To: Soehner, Gage A.
Cc: King, Kevin
Subject: RE: CBL Deferment Request -- HMU Federal 16-16C2 -- 045-20408

EnCana CBL Deferment Request

| Well Name: | HMU Federal 16-16C2 |
| API Number: | 05-045-20408 |

TEMPERATURE PLOT

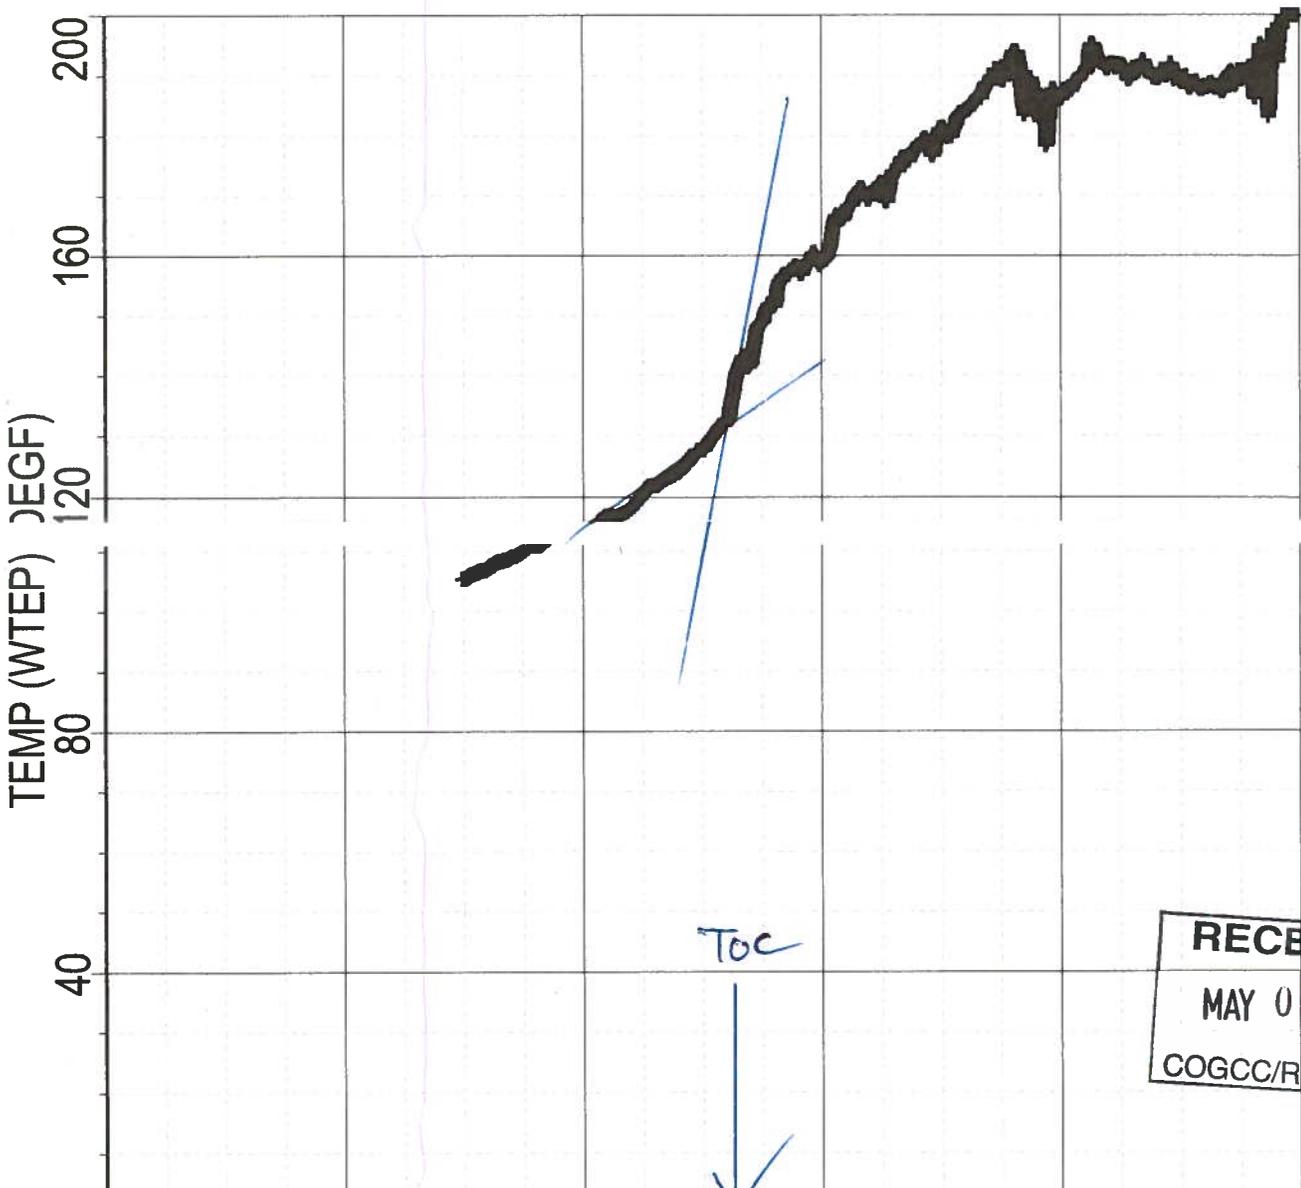
For future requests, could you also provide one more piece of data: how much, if any, fluid was needed to keep the well-annular space full for the 72 hours after the cementing was done? You are probably familiar with the COGCC Mamm Creek Field Notice to Operators: item #1 under the Procedure and Reporting Changes requests this information.

JK picks
~ 5200"

Encana can defer the CBL on the subject well.
